SERVICE BULLETIN

#0004 Revision 1

SUBJECT: Placement of the ELT antenna

Figure 2

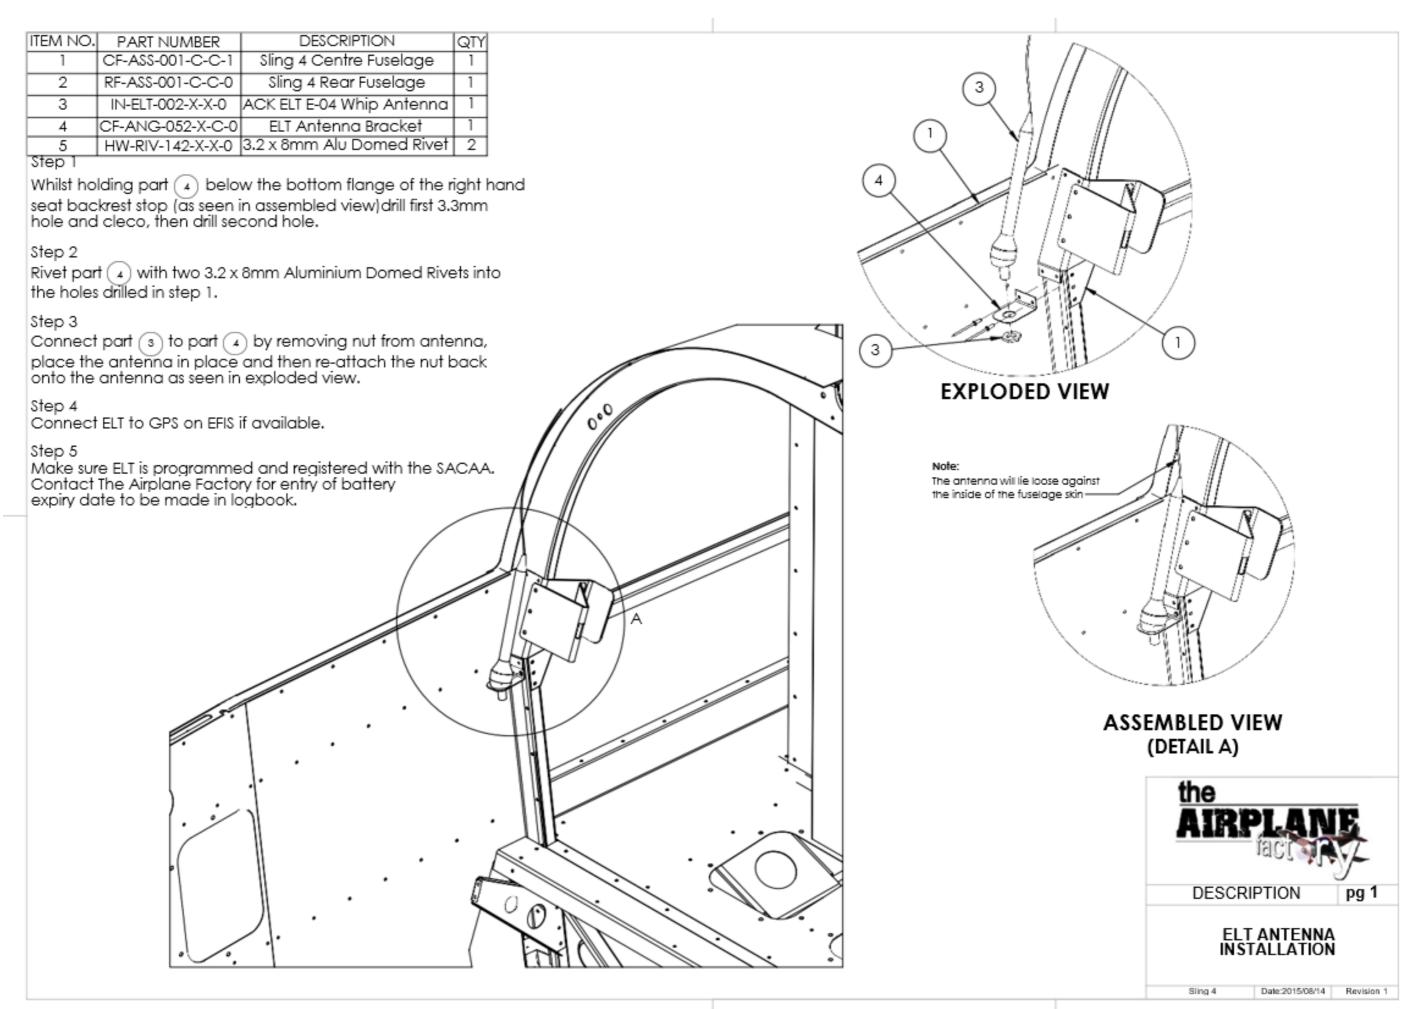
If the **ACK E-04** ELT antenna is mounted in any place other than what is stipulated in this service bulletin, then this service bulletin will apply. The installation instructions in Figure 2 on the following page illustrate the correct installation.
